SERVICE BULLETIN 111

REDUCTION OF FORCE REQUIRED TO OPERATE PARACHUTE TYPE TOP VENTS

Revision A

DRAWING AMENDMENT NO. 145 SH. 1 OF 1 DATE 3-25-80 1K

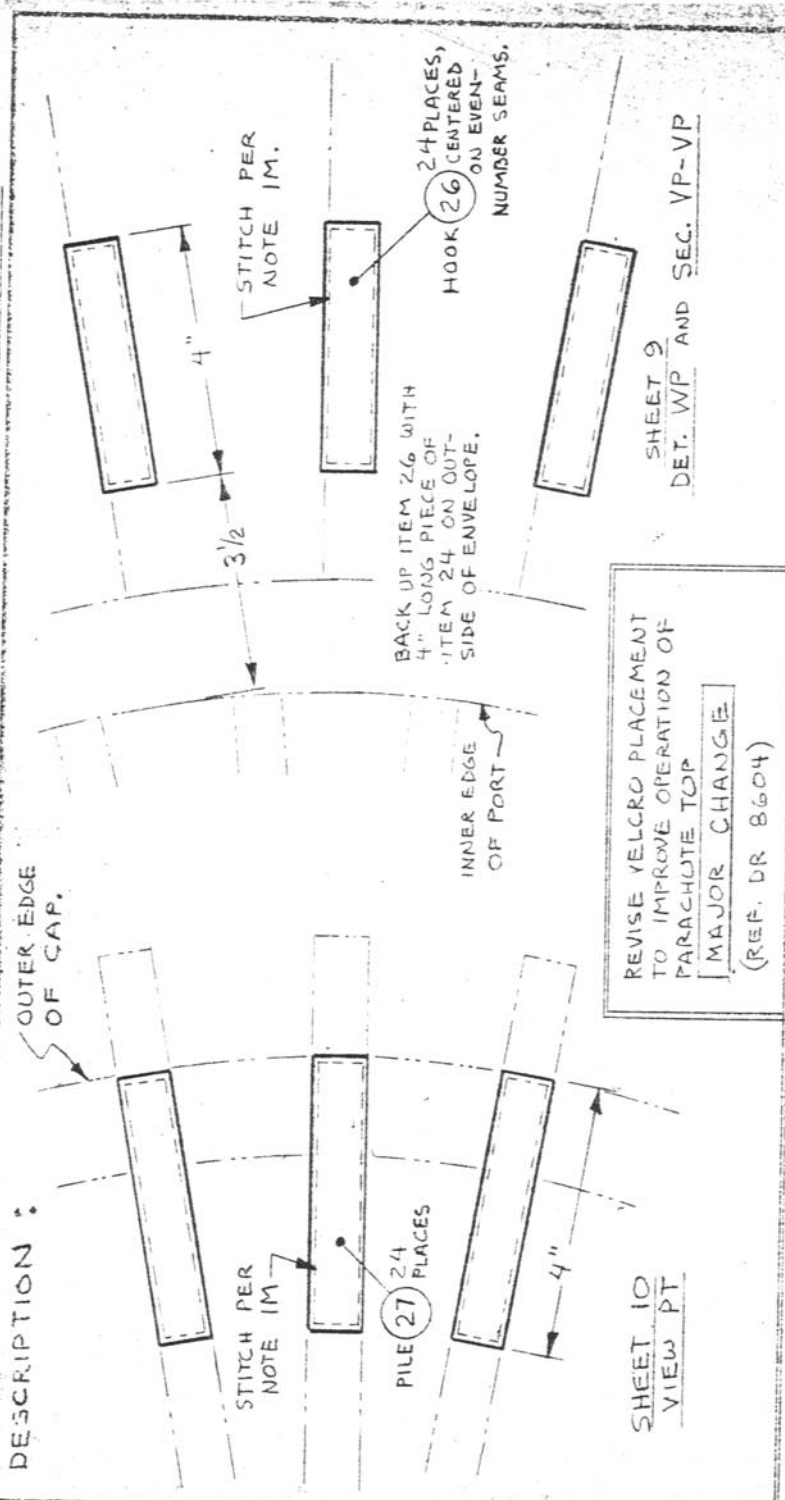
Remove the pieces of Velcro hook located directly below the deflation port and relocate by sewing the 4 inch long 1 inch wide pieces of Velcro hook in position such that the 4 inch pieces of Velcro hook are located vertically on the even numbered half gore seams with one end located 3½ inches and the other end located 7½ inches from the edge of the deflation port. This positioning of the pieces of Velcro hook is oriented 90° from that of the original design.

Remove the pieces of Velcro pile located on the parachute top and relocate by sewing the 4 inch long 1 inch wide pieces of Velcro pile in position such that one end of the 4 inch pieces of Velcro pile is located even with the edge of the parachute top and that the other end of the four inch piece of Velcro pile is located four inches from the edge of the deflation cap. Again, this new positioning of the Velcro is oriented 90° from that of the original design.

REVISE VELCRO PLACEMENT TO IMPROVE OPERATION OF PARACHUTE TOP
 MAJOR CHANGE
 (REF. DR 8604)

STITCH PER NOTE 1M

PILE (27) 24 PLACES

STITCH PER NOTE 1M.

BACK UP ITEM 26 WITH 4" LONG PIECE OF ITEM 24 ON OUT-SIDE OF ENVELOPE.

HOOK (26) 24 PLACES, CENTERED ON EVEN-NUMBER SEAMS.
